AMENDMENT 006	01/05/16
Revisions:	Date

Project Title: CLC ROAD LOOP FINAL WEAR COURSE
Location: Milwaukee VAMC, Milwaukee WI
Date: 09/11/2015

Project Number: 695-16-113
Building Number:
Drawing Number: C100
Dwg. 4 of 12

C400

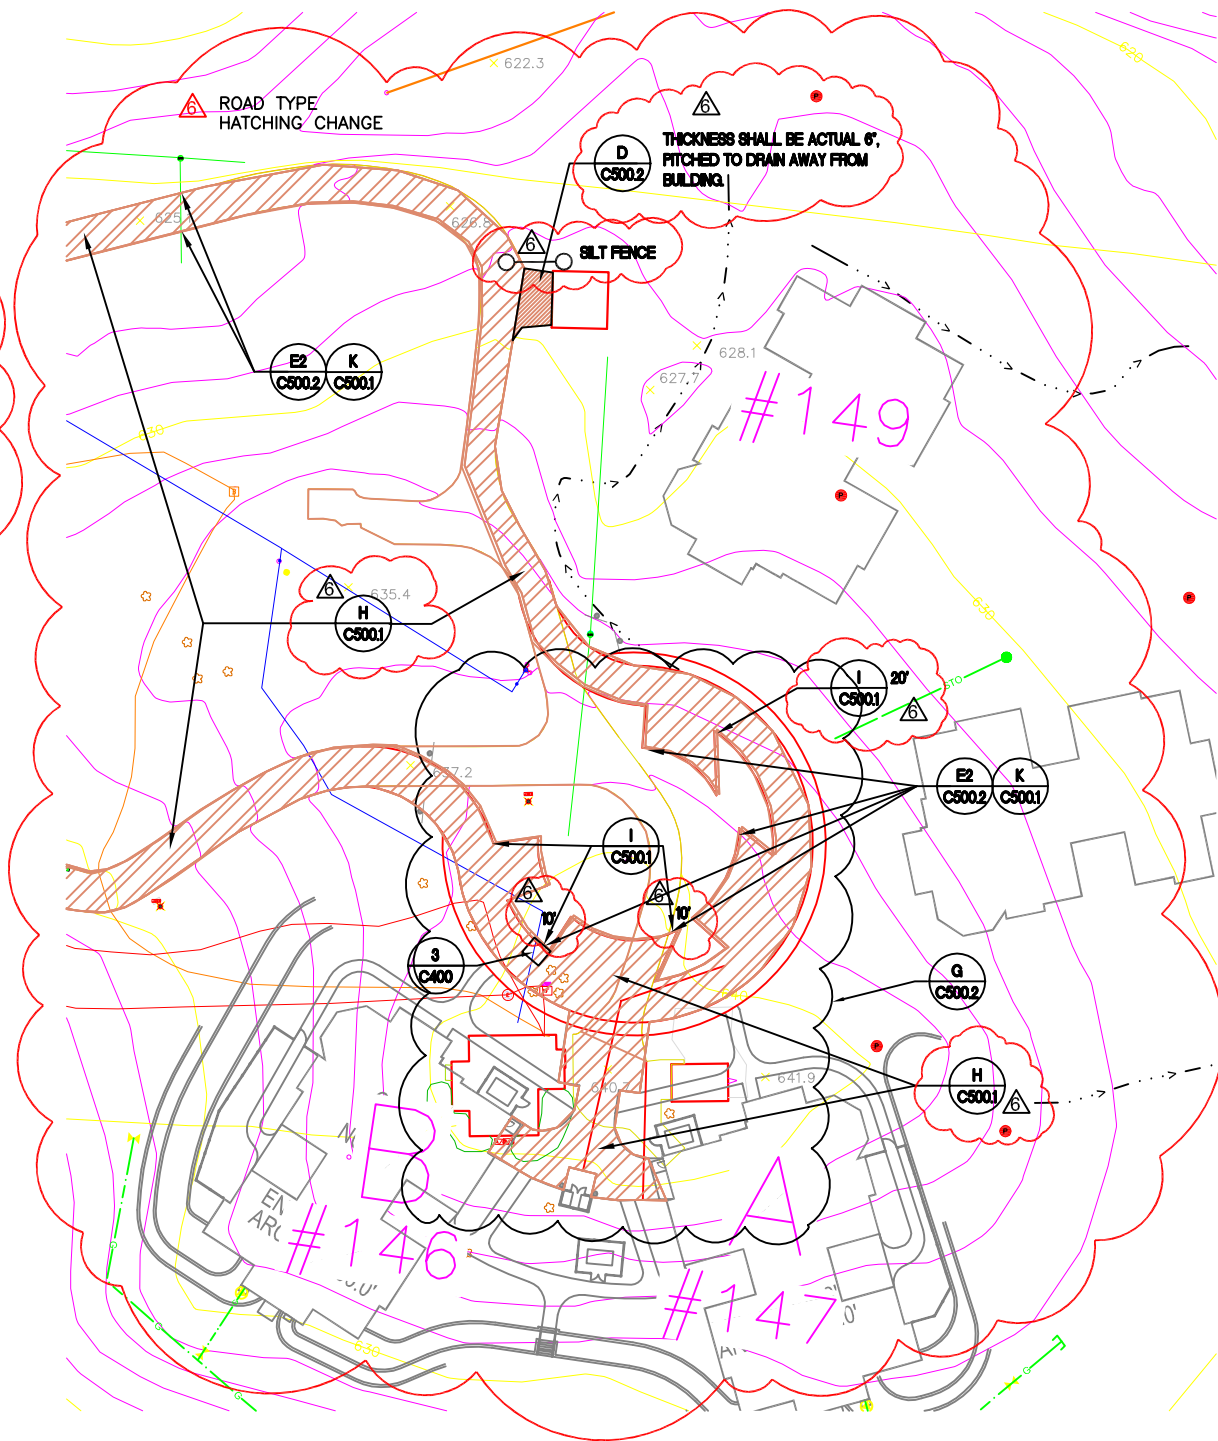
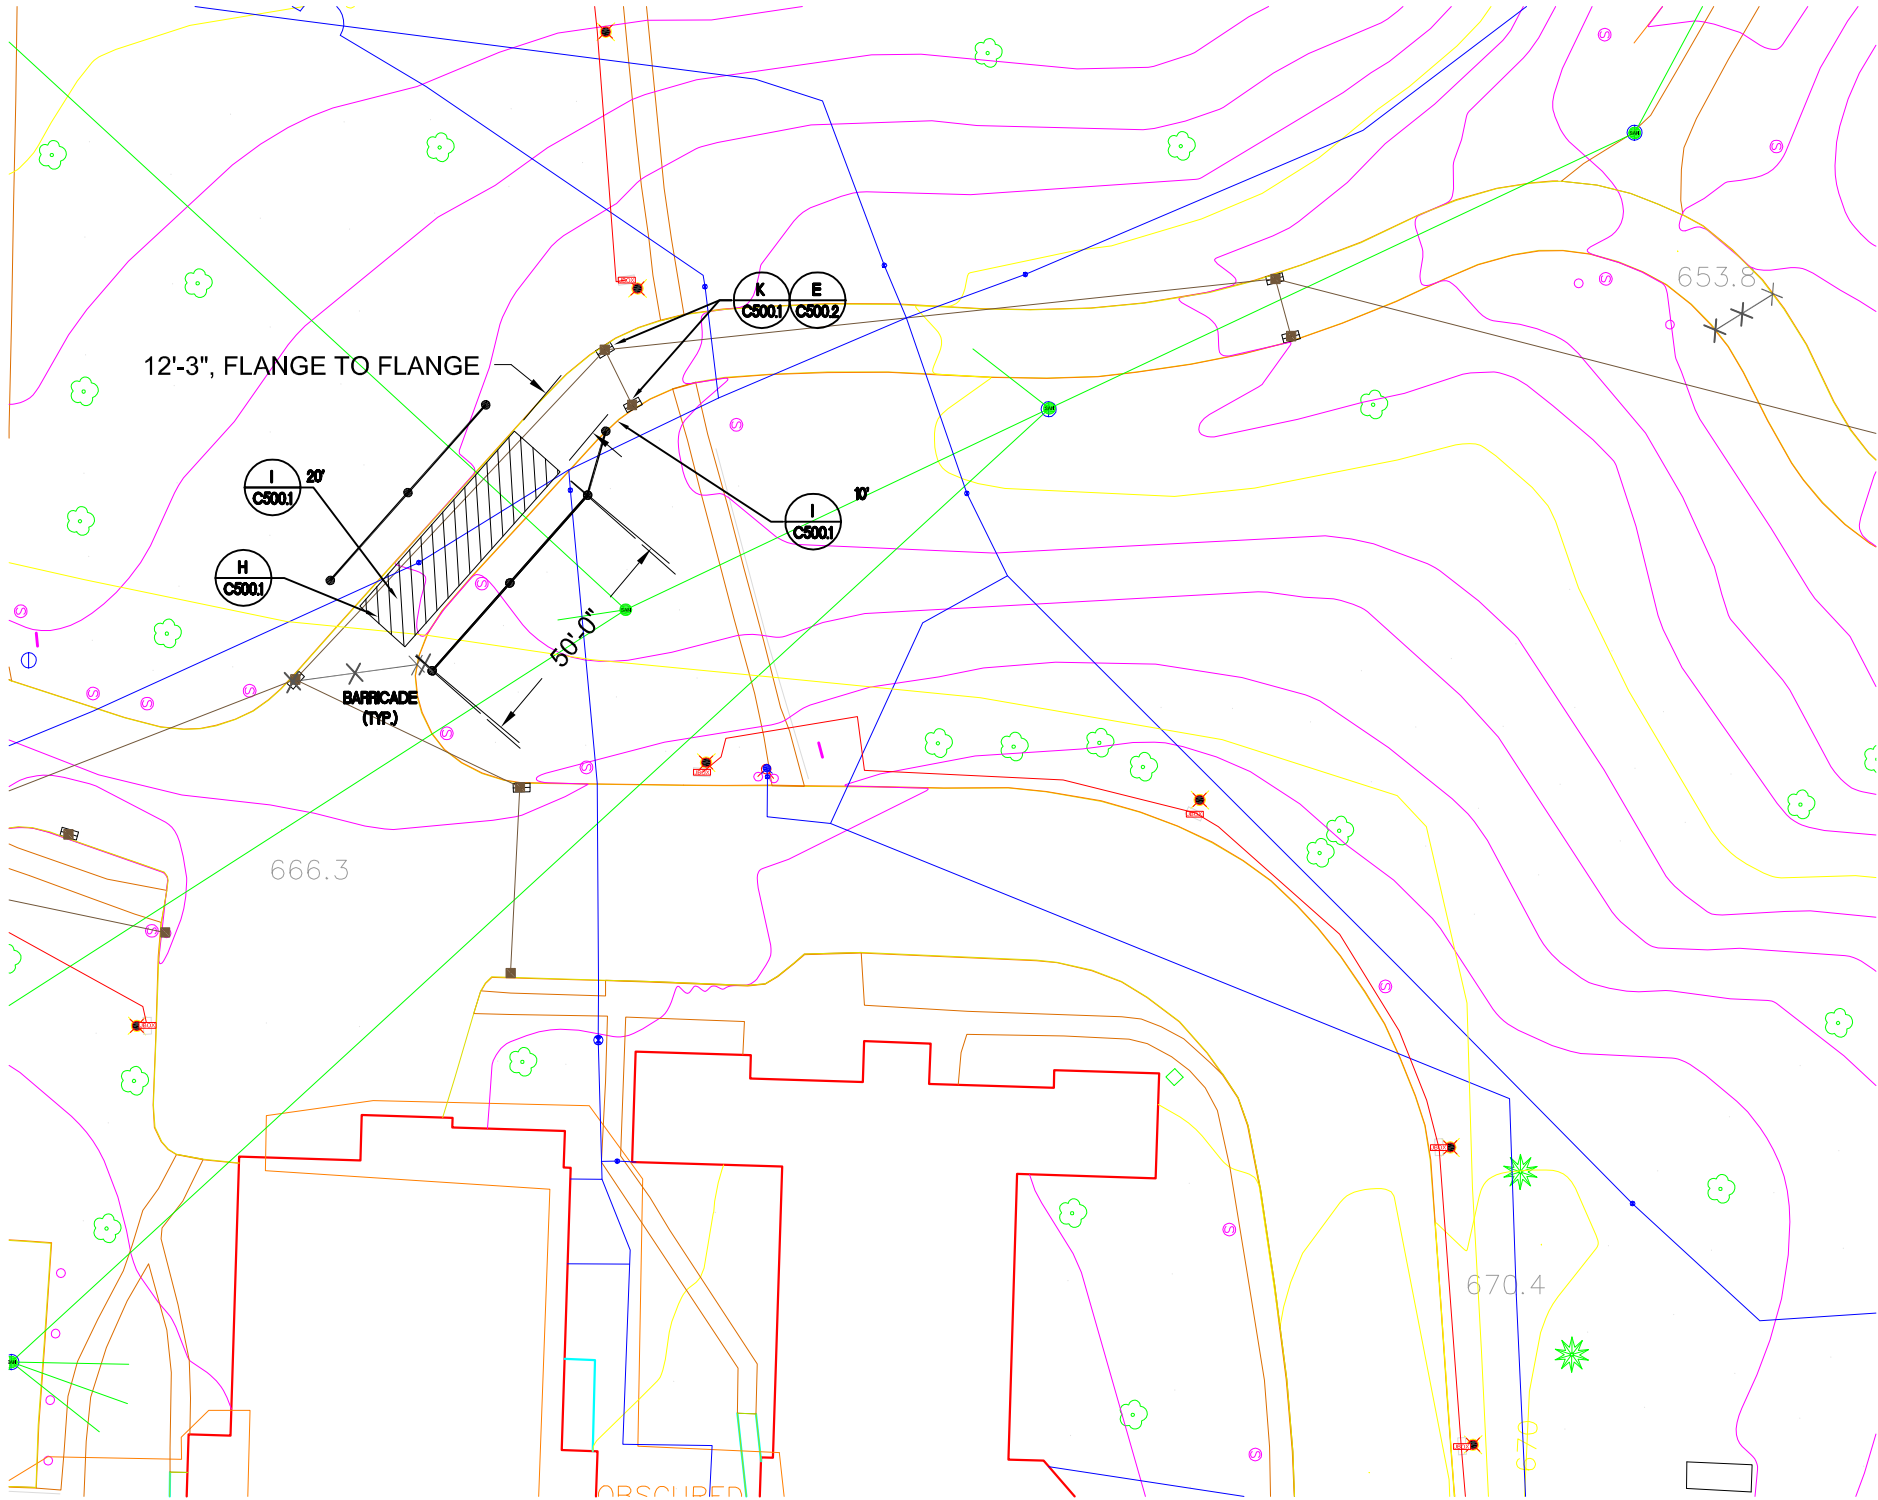
2. WHERE RAMPS ARE LOCATED ABUTTING CONCRETE CURB AND GUTTER, ALLOW FOR 28' REMOVAL AND REPLACEMENT OF CURB AND GUTTER. WHERE ASPHALT, ALLOW 18' OF NEW CURB AND GUTTER PER DETAIL

Drawing Number:
C400.1
Dwg. 8 of 12

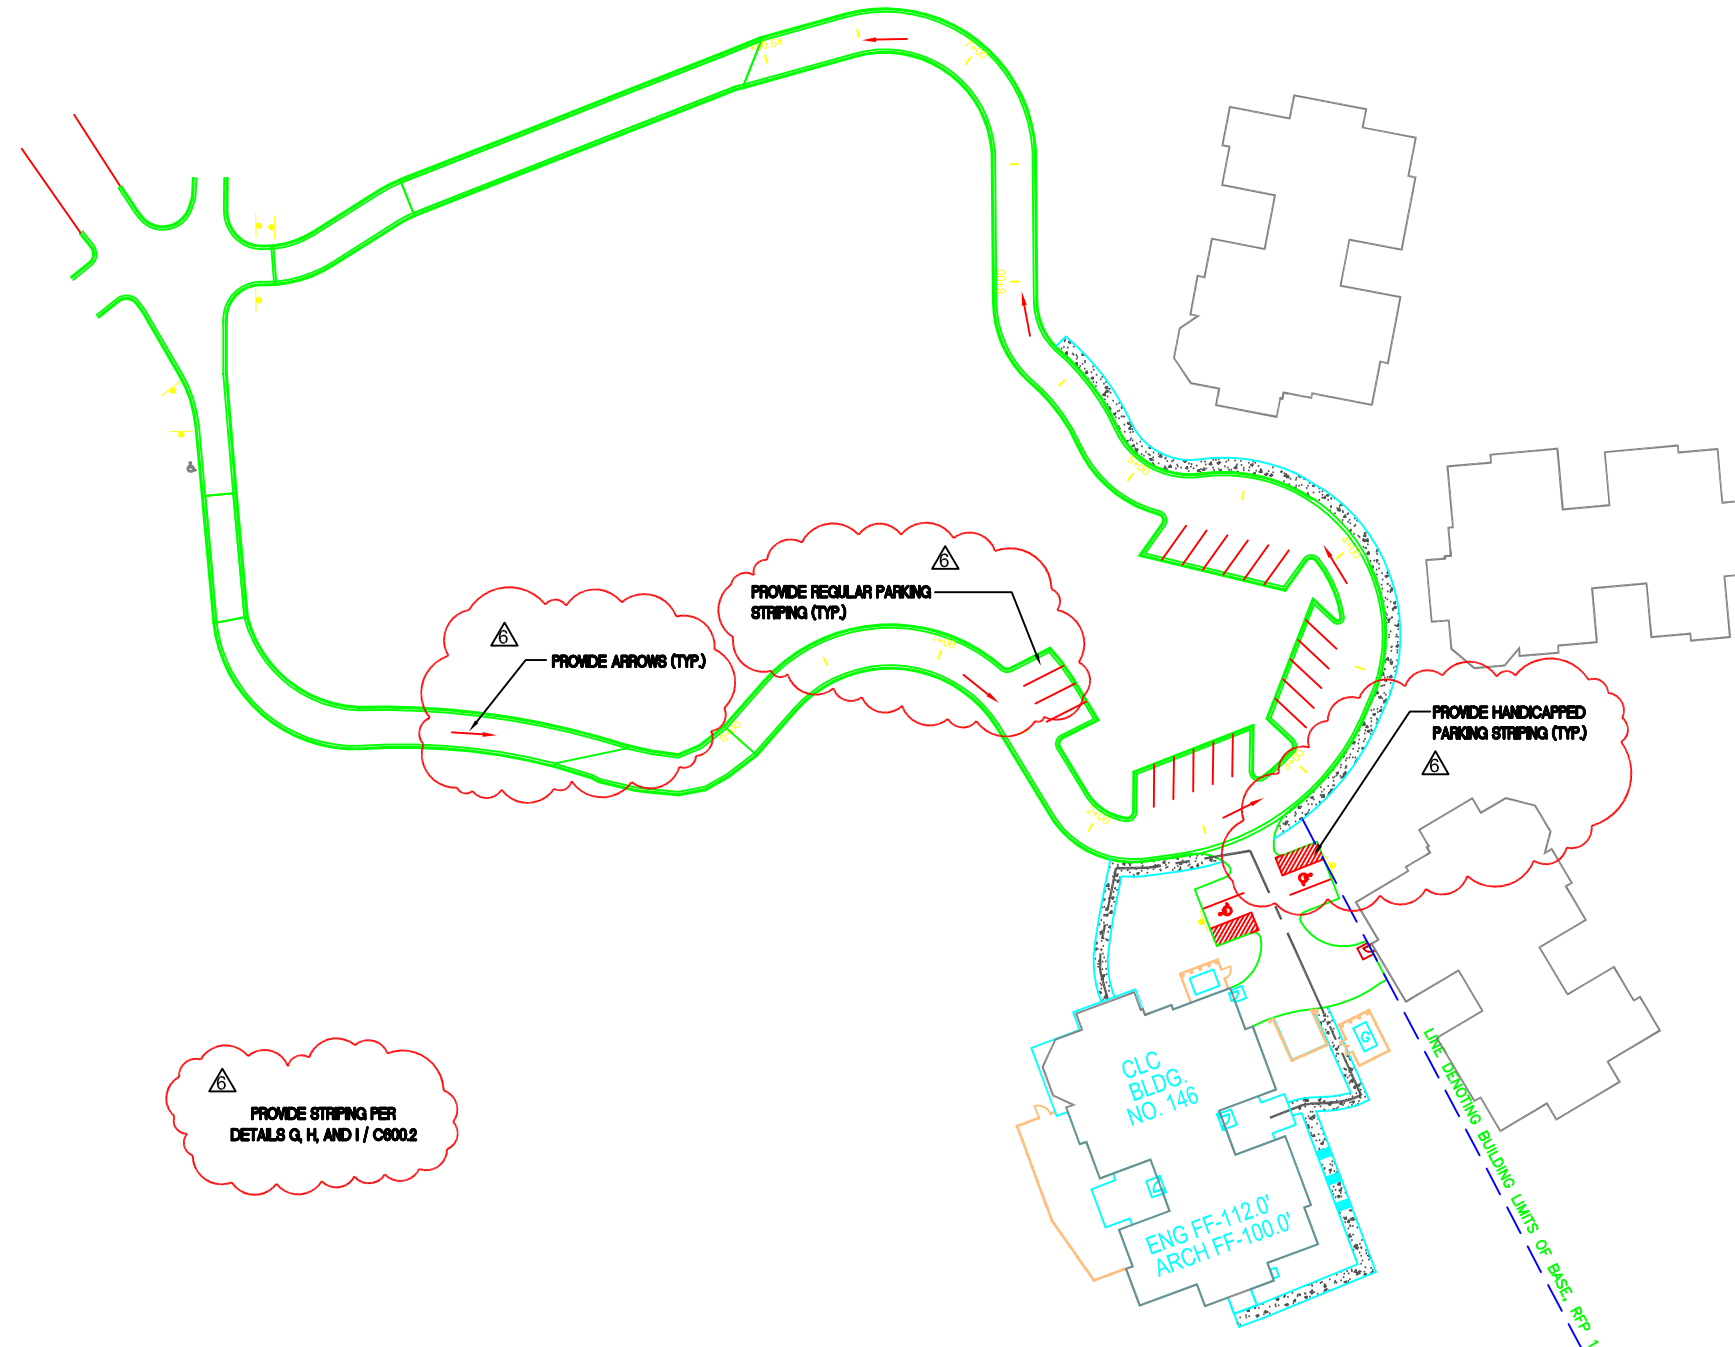
- 1) MODIFY H/C5001 TO MILL 4", REPLACE WITH 4" NEW ASPHALT TO MATCH EXISTING GRADE. NO GLASSPAVE 25.
2) WORK SHALL BE WEEKEND WORK.
3) PROVIDE DETOUR SIGNAGE.

NEW SHEET

H SCARIFY/MILL AND WEARING COURSE
N.T.S.

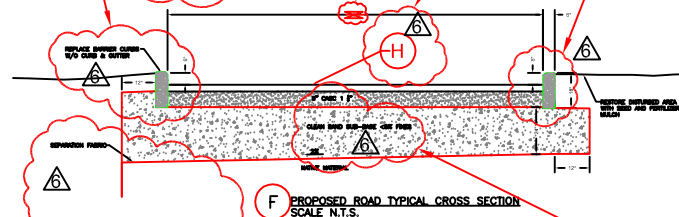
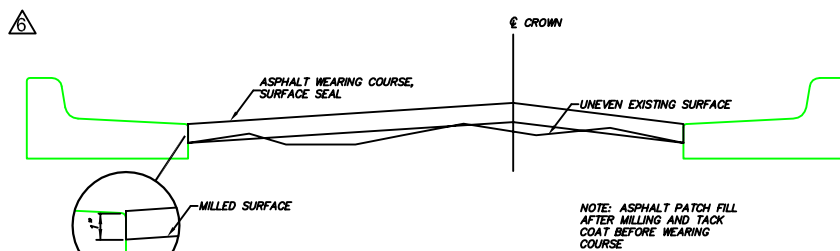
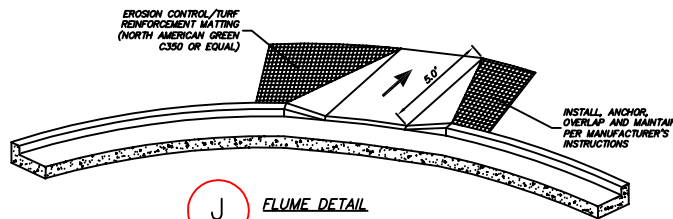
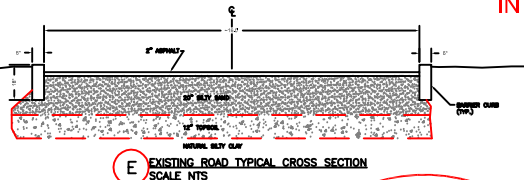
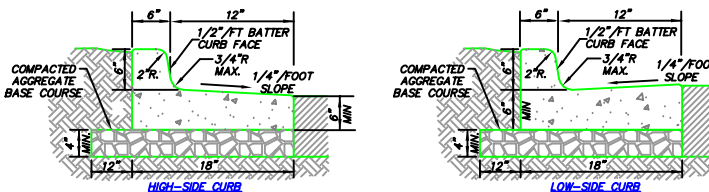
RELOCATED DETAILS H
AND I, MODIFIED NOTES

FOR NEW RAMPS ON
BARRON CT REPLACE
18" OF ASPHALT CURB
PER LOCATION
NO GUTTER (TYP.).

MODIFIED DETAIL REFERENCED.

DELETED
TRENCH
DRAIN

NOTE: PROVIDE GLASSPAVE
25 OVER LEVELING COURSE
FOR OLD ROADS

CLC ROADS: NO GLASS
PAVE 25.

I CONCRETE CURB & GUTTER DETAIL

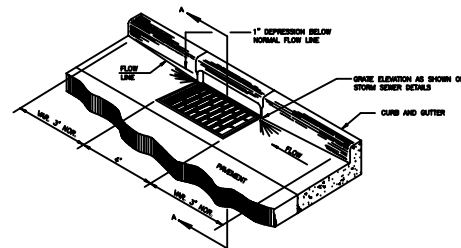
DELETED DETAILS
A-D. MOVED
DETAIL J HERE.

K CATCH BASIN DETAILS
NO SCALE

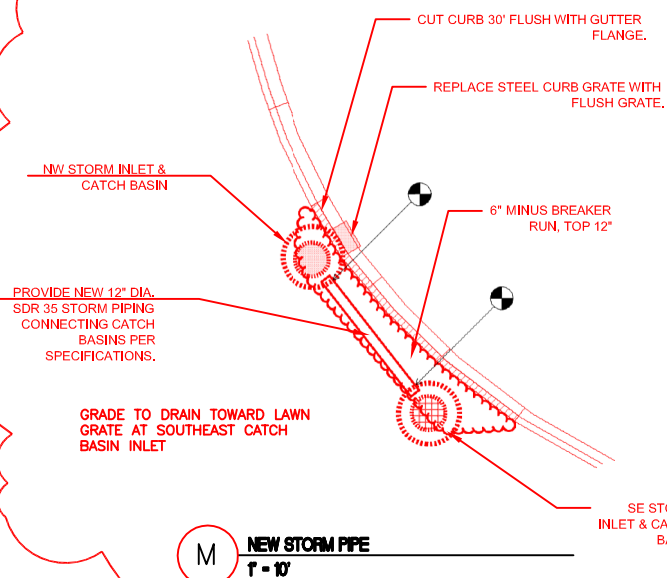
FOR REPAIRS
EXCAVATE AROUND BASIN, SAWCUT
WALLS, REBUILD WITH CAST-IN-PLACE
CONCRETE 8" THK., DOWELED INTO
EXISTING. DOWELS: #5@24" O.C.
EPOXY COATED, SET IN EPOXY DOWEL
HOLE.

DELETED DETAIL L.
ADDED DETAIL M.

CC PAVEMENT SECTION OLD ROADS REPLACEMENT (NOT IN CONTRACT)
SCALE: N. T. S.
WORK ASSOCIATED WITH THIS TYPICAL SECTION INCLUDES ASSOCIATED DEMOLITION, PREPARATION AND RESTORATION ONCE CONSTRUCTED

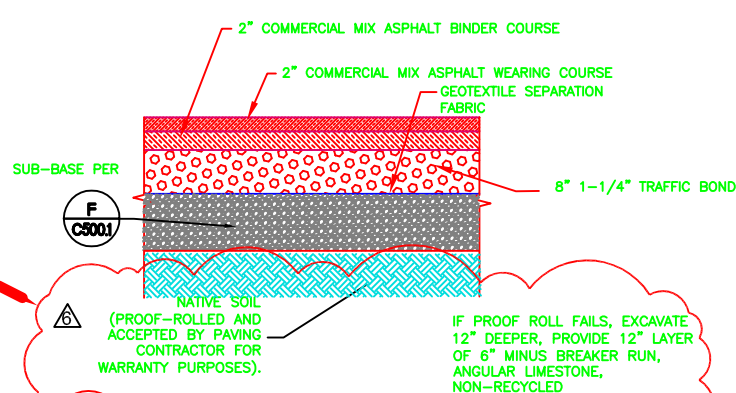
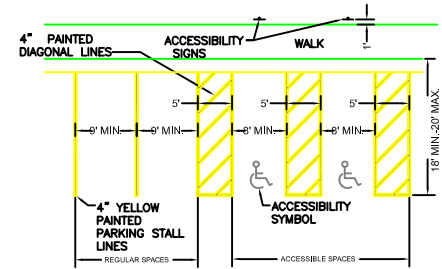
TITLE AND NOTES MODIFIED
